February 3, 2010
U7-C-STP-NRC-100033

South Texas Project
Units 3 and 4
Docket Nos. 52-012 and 52-013
Response to Request for Additional Information

Attached are the responses to the NRC staff questions included in Request for Additional Information (RAI) letter number 240 related to Combined License Application (COLA) Part 2, Tier 2, Section 17.4. This submittal completes the response to this RAI letter.

Figure 17.4S-1 Reliability Assurance Process

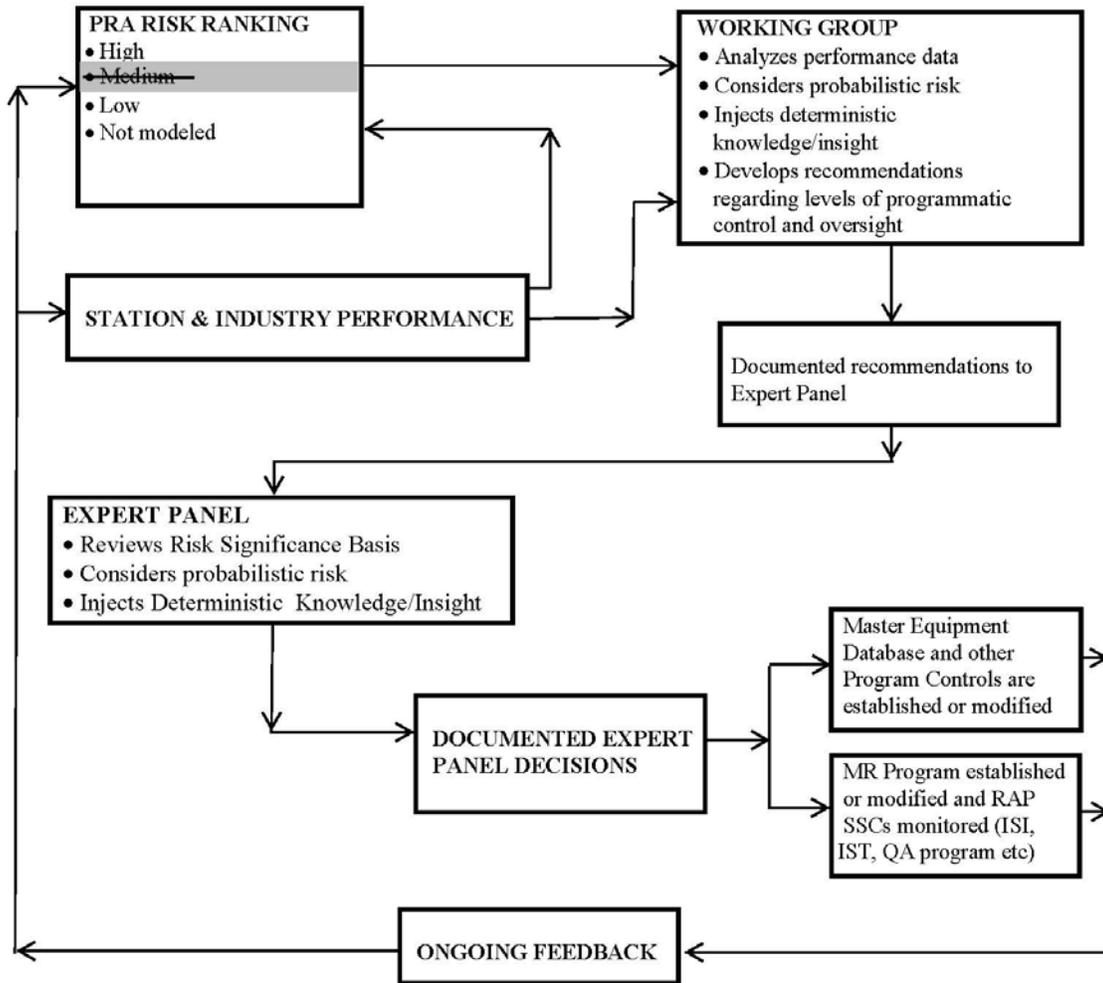
The term "PRA Medium" will be removed from Figure 17.4S-1 and from Figure 17.4S-2 (by deleting Figure 17.4S-2 since it only provided information already included in the text).

The qualitative risk analyses (e.g., SMA and FIVE) and PRA models for which risk importance measures are not available were evaluated in the ABWR DCD Appendix 19K. As part of D-RAP they will be addressed by the Expert Panel as shown in FSAR Figure 17.4S-1 (no revision to COLA Section 17.4S.1.4 is required to reflect this).
